PG&E Letter DCL-15-095

Response to NRC Request for Additional Information Regarding Recommendation 2.1  
of the Near-Term Task Force Seismic Hazard and Screening Report

## Response to NRC Request for Additional Information Regarding Seismic Hazard and Screening Report

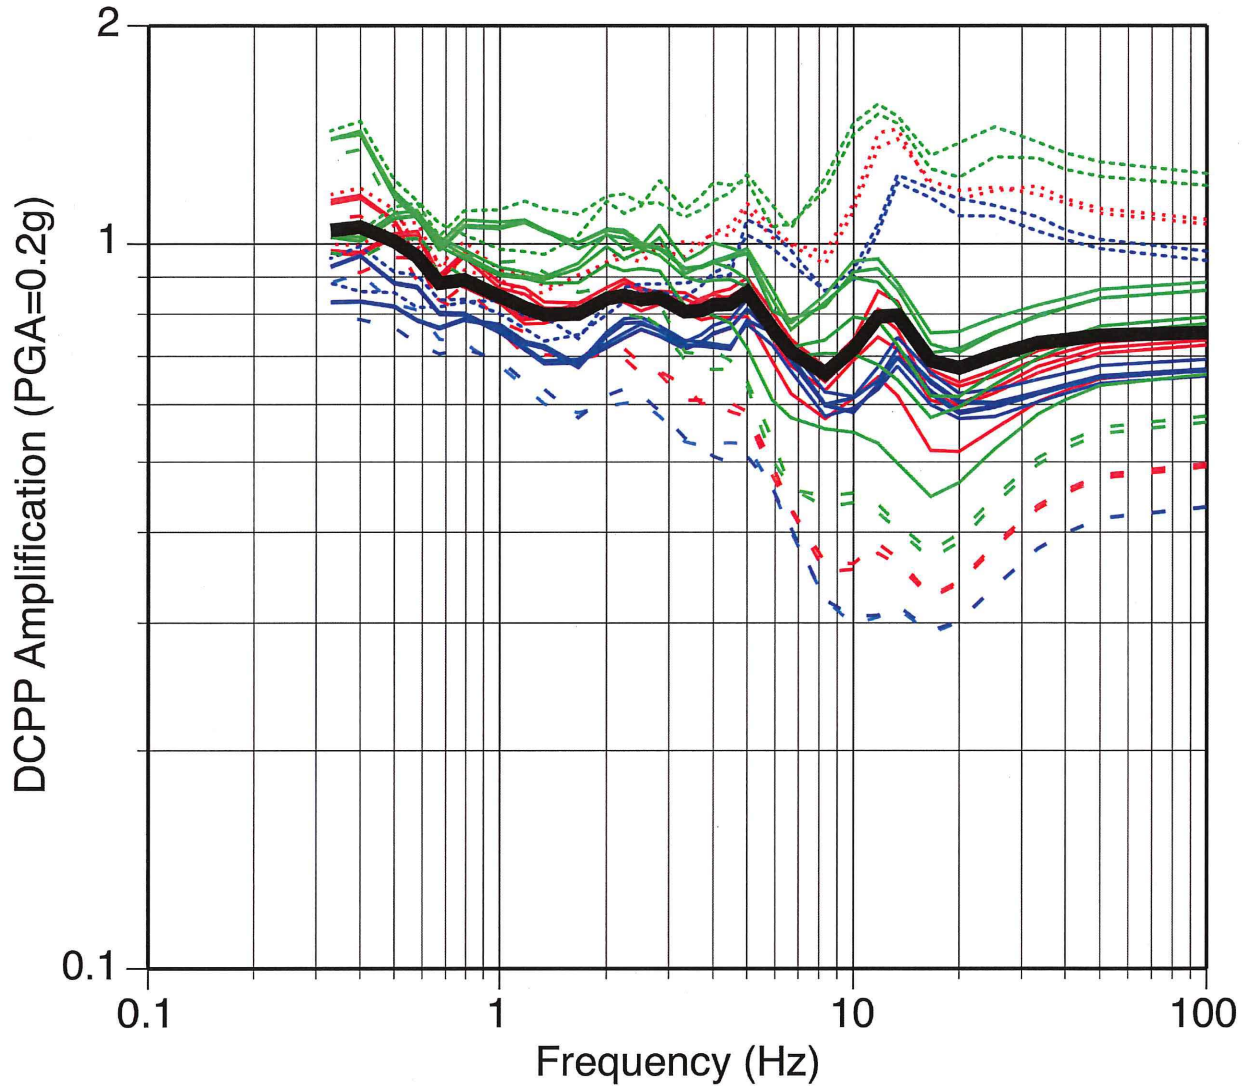
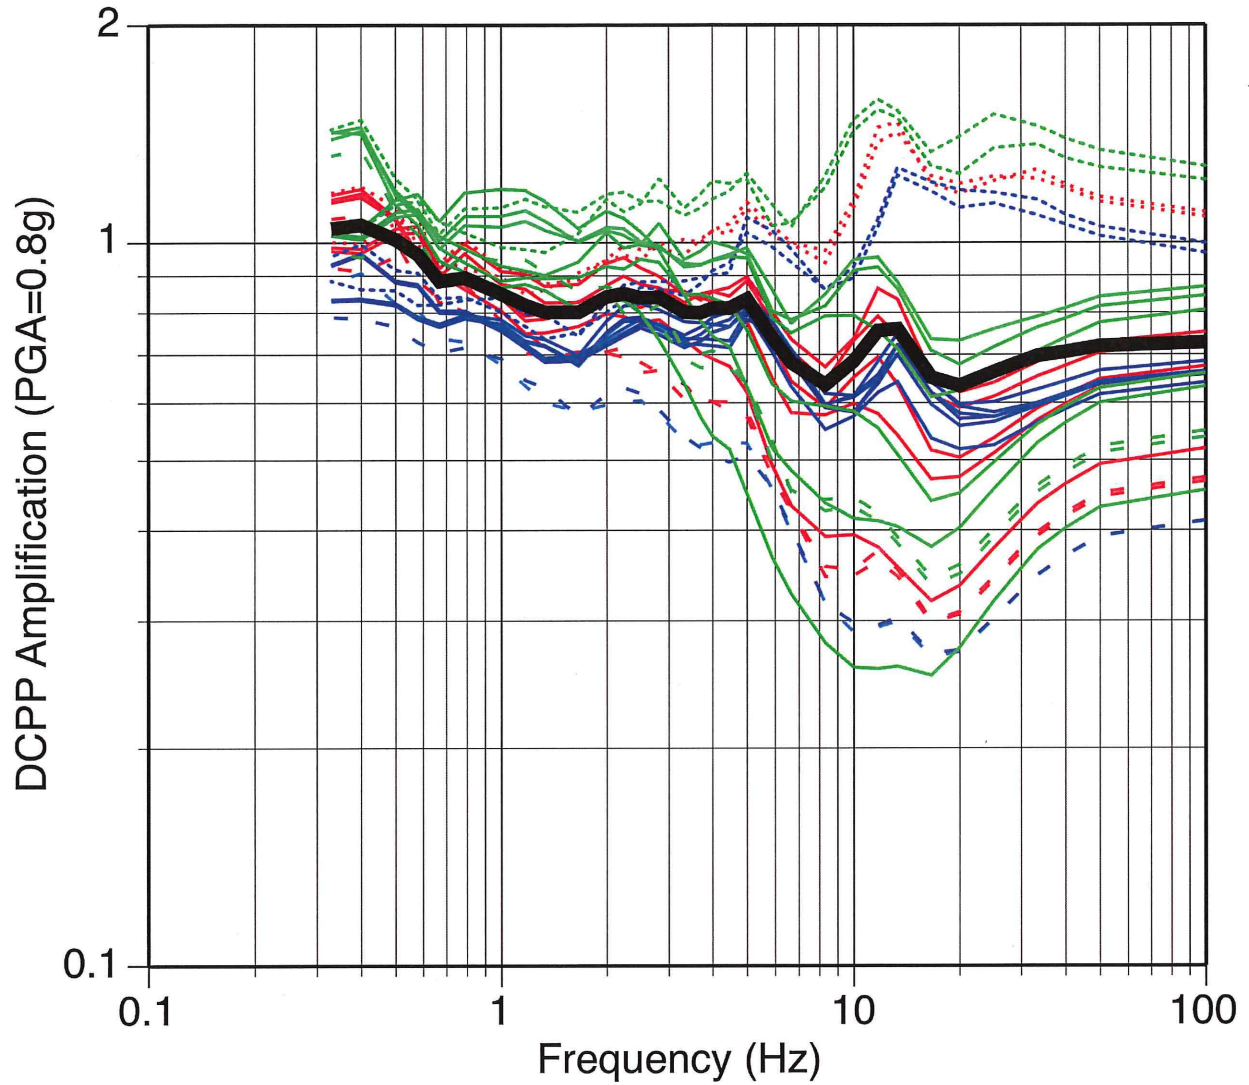
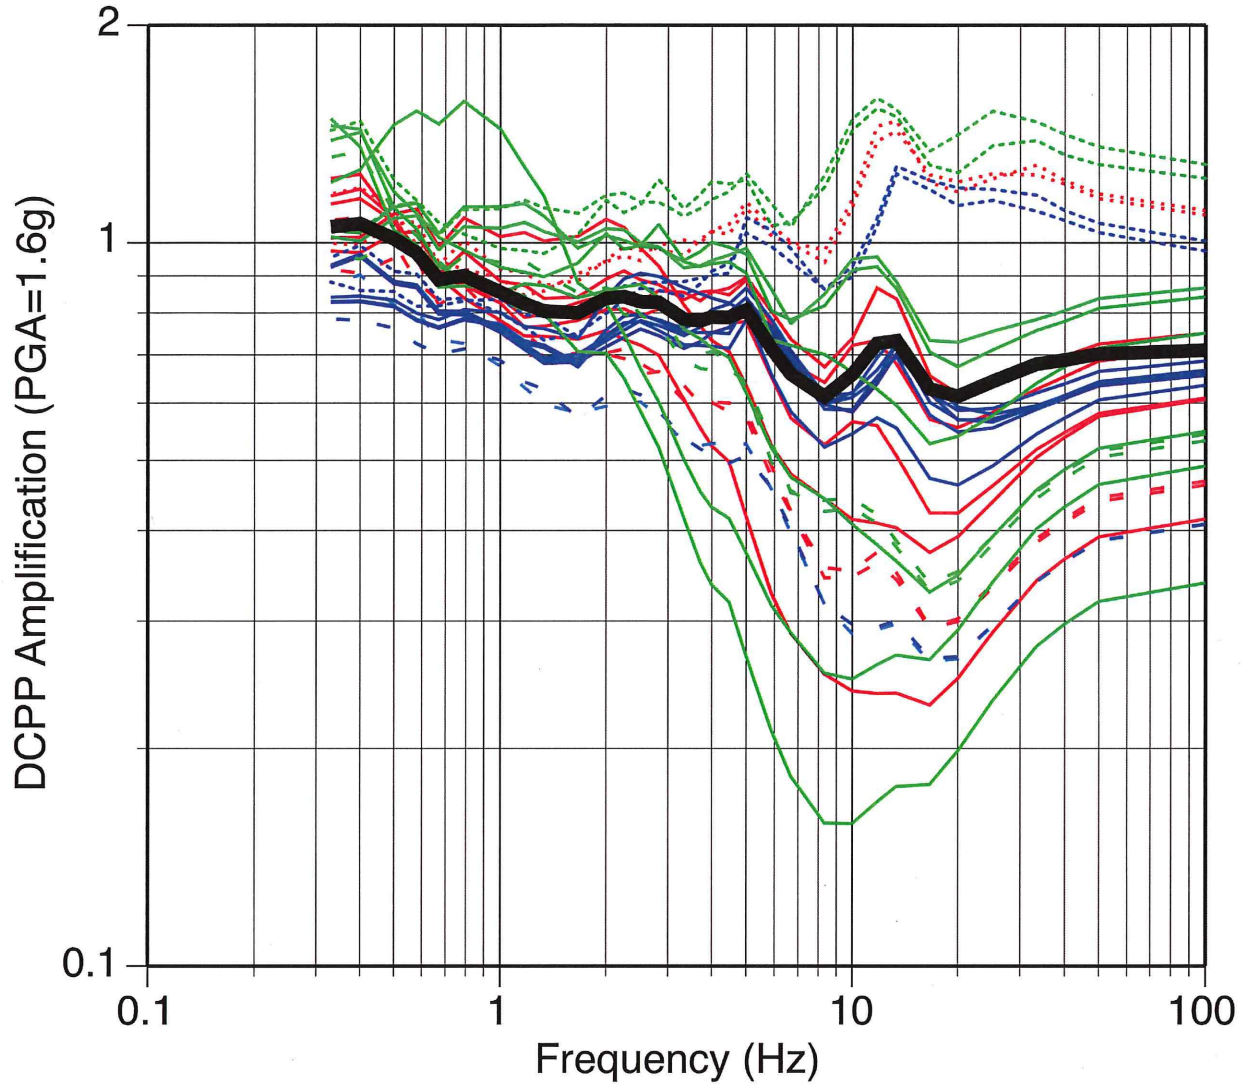
In addition, provide the adjustment factors (VS-kappa corrections) needed to modify the median ground motion models for the selected reference or baserock elevation and velocity. Also include in the response, as a figure and a table, control point seismic hazard curves developed using the site amplification factors and their uncertainties through the hazard integral as recommended in Appendix B of the SPID.

Using the material properties described in the response to NRC Question 1, the amplification factors (VS-kappa corrections) for the median ground motion are shown in Figures 4-1, 4-2, and 4-3 for reference rock PGA values of 0.2g, 0.8g, and 1.6g, respectively. The group of larger amplification factors at high frequencies is associated with the lower kappa value of 0.024 sec.
